### Observation 3

Future Neighborhood Access –

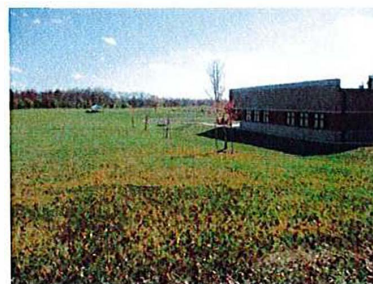
Neighboring community recently informed school district of intention of making an entry onto the school grounds on the back northeast side of the property.

The current location could potentially invite intruders onto the property in proximity of students near cafeteria. With deliveries being made to this area, it would increase the potential of intruders attempting to gain access due to location. Work with all stakeholders to propose new location of entry at the front of the school where pedestrian traffic can be more easily monitored and potential threats can be more easily recognized.
